SEPTEMBER 26, 2007

RE: CONGREGATION SHEARITH ISRAEL'S SEPTEMBER 2007 BSA APPLICATION

I have reviewed the September 10, 2007 response by Congregation Shearith Israel (CSI) to BSA's June 15 Notice of Objections. Several of CSI's responses are inadequate - they are either incomplete or fail to address the questions raised by BSA in its various objections. I provide detailed analysis of each inadequate response below:

AOR-3

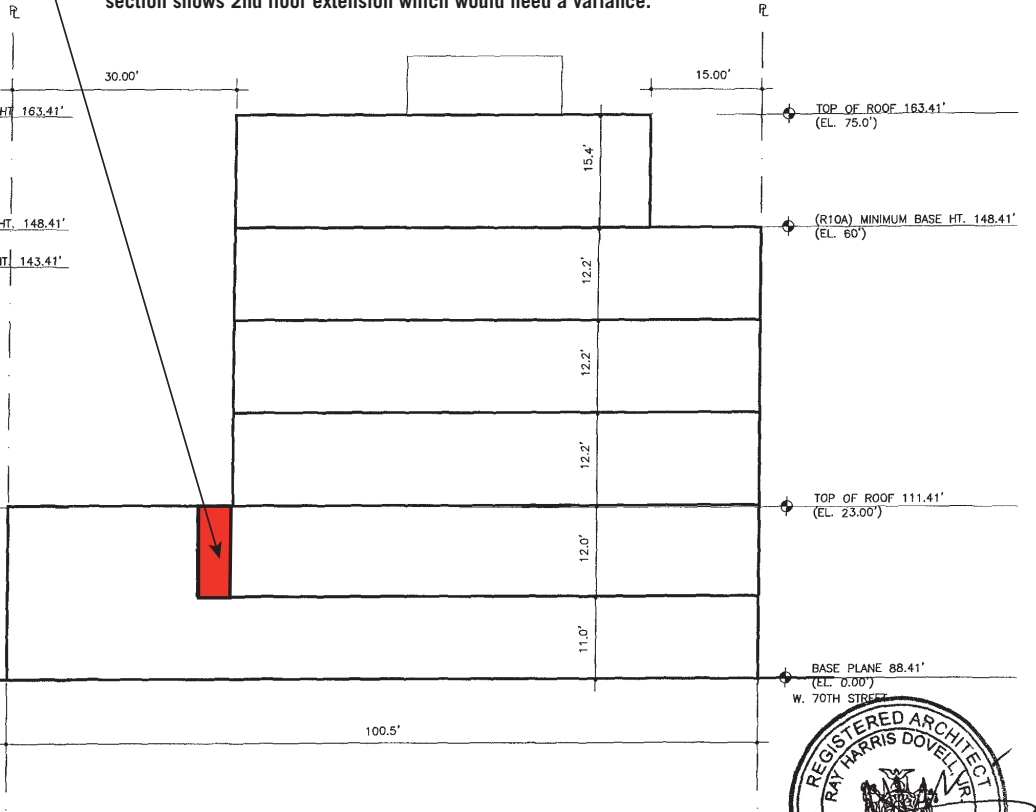
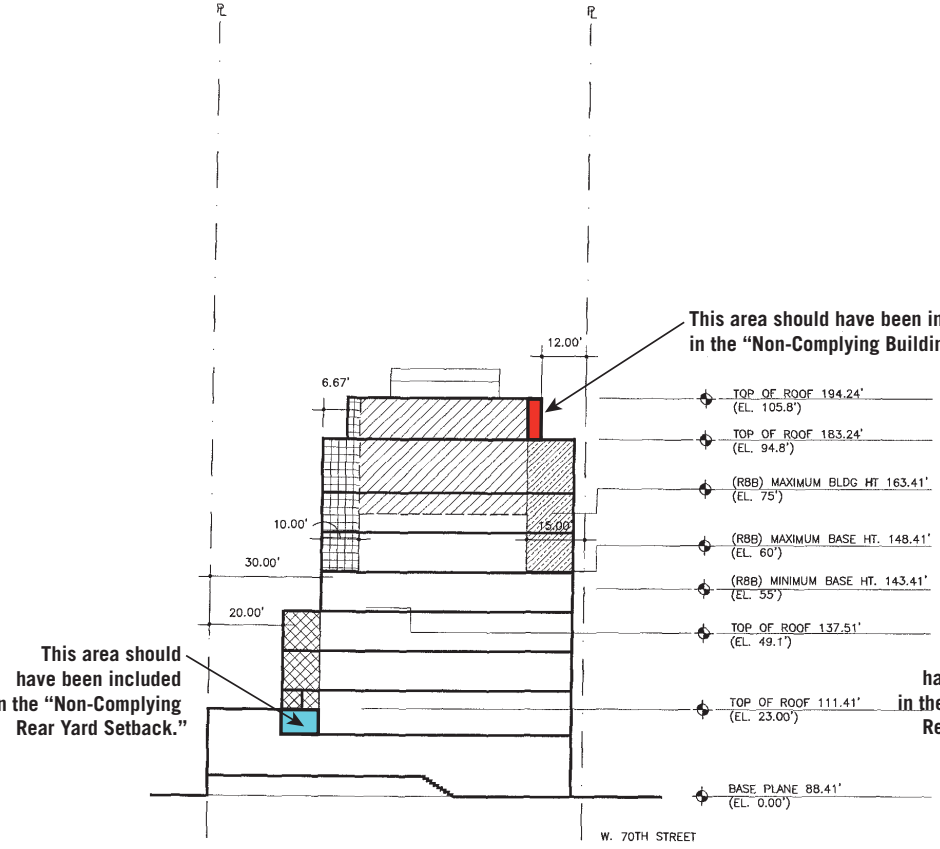
CSI uses AOR-1 and up as the identifying code for three separate sets of "As-of-Right" drawings. This is unnecessarily confusing. Each drawing should have its own unique identifier to avoid confusion when referring to it. There are THREE separate AOR-1 drawings! Also there is a small error in the As-of-Right Drawings Versions A and B drawings AOR-3. In the sections provided, the second floor is shown as extending into the Required Rear Yard. ZR § 24-33(b) is clear that only a single story of Community Facility Use is an allowable obstruction. This single story may be up to 23' tall. The plans for the Second Floor appear to be correct - allowing the full 30' Rear Yard, but these sections show an incorrect dimension and would require a variance if the Second Floor were to extend into the 30' Rear Yard (See attached AOR-3 with mark-up).

These two areas should be included in the Ground Floor. The As-of-Right 2nd Floor Plan (AOR-9) is correct - but this section incorrectly shows a 2nd floor which extends into the Required 30' Rear Yard. Without a correction, this section shows 2nd floor extension which would need a variance.

PROPOSED AREAS OF NON-COMPLIANCE CONGREGATION SHEARITH ISRAEL		CAL. NO. 74-07-BZ Platt Byard Dovell White Architects LLP 20 West 22nd Street New York, NY 10010 212.691.2440 212.693.0144 fax
6-10 WEST 70TH STREET NEW YORK, NY	08.28.07 #02350	P-3

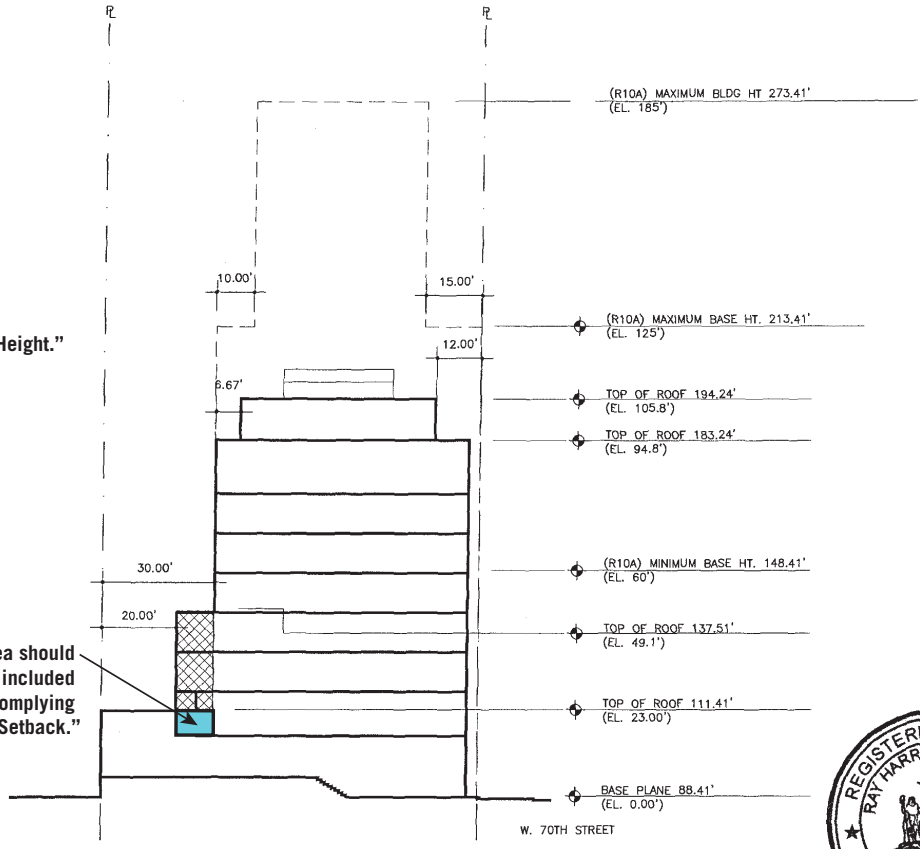
1. First, they state that they have a noncompliance because of "rear yard exceedances for the third and fourth floors." This should read "rear yard exceedances for the second, third and fourth floors." The architect's sections on drawing P-3 shows that the second floor also obstructs the Required Rear Yard - although the diagrams do - in another error - leave out a small section of non-complying 2nd floor. (See attached P-3 with mark-up).

There are some errors in the Proposed Areas of Non-Compliance Drawings on drawings P-3 and P-4. See attached diagram showing error in the areas identified as "Non-Complying Rear Yard Setback" and "Non-Complying Building Base Height/Non-Complying Setback Above Base." (See attached P-3 and P-4 with mark-up).

PROPOSED AREAS OF NON-COMPLIANCE		Platt Byard Dovell White Architects LLP 20 West 22nd Street New York, NY 10011 212.691.2440 212.633.0144 fax	
CONGREGATION SHEARITH ISRAEL		6-10 WEST 70TH STREET NEW YORK, NY	08.28.07 #02350 P-4

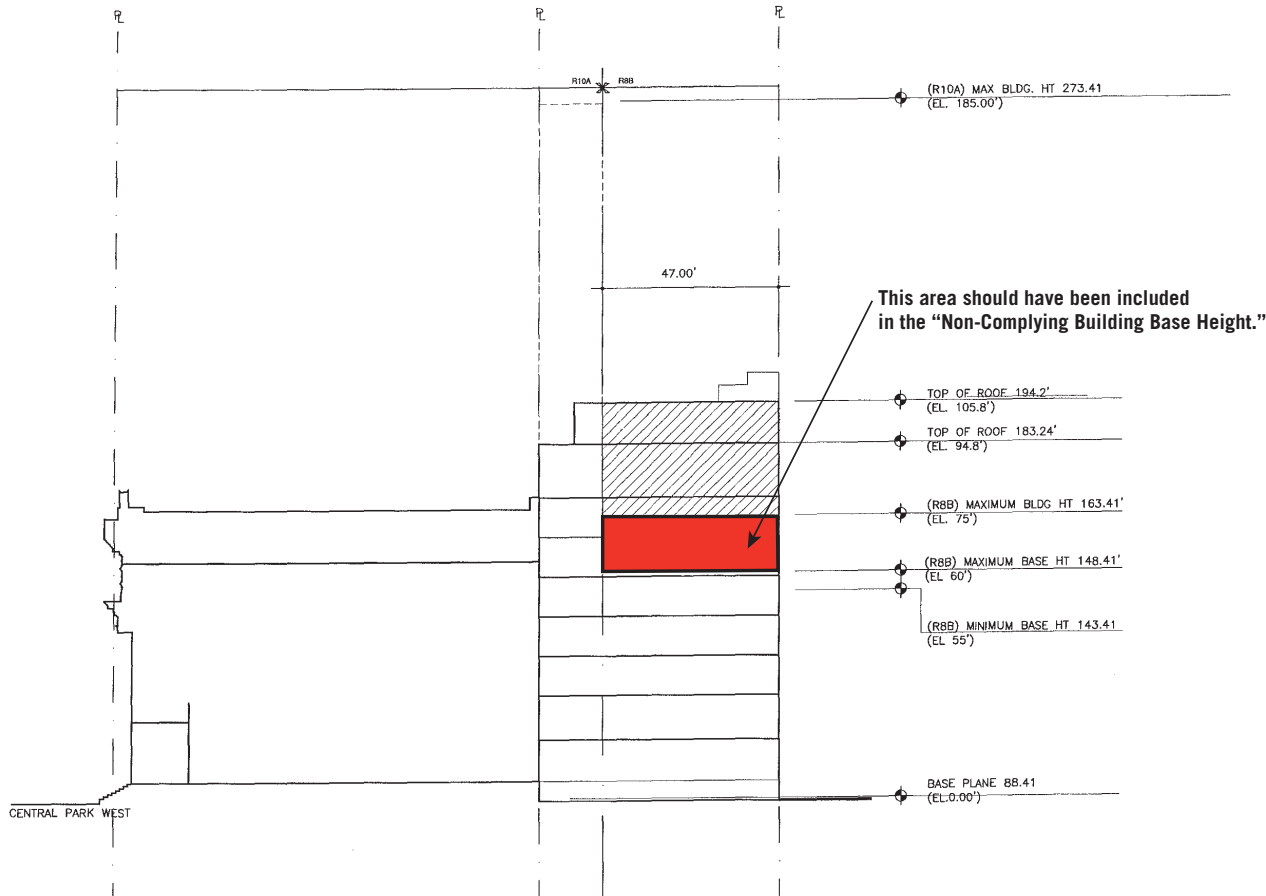
2. Second, they state that they have a noncompliance because of "R10A and R8B base and building height exceedances." This should read "R8B base and building height exceedances." Their Proposed Building does not exceed either the maximum base height or maximum height regulations for R10A. Their variance is required for only the R8B portion of the building - as clearly shown on the architect's section on drawing P-4 - although this drawing also makes another error in that it fails to show the "Non-Complying Building Base Height" above 60' in the R8B zone. (See attached P-4 with mark-up).
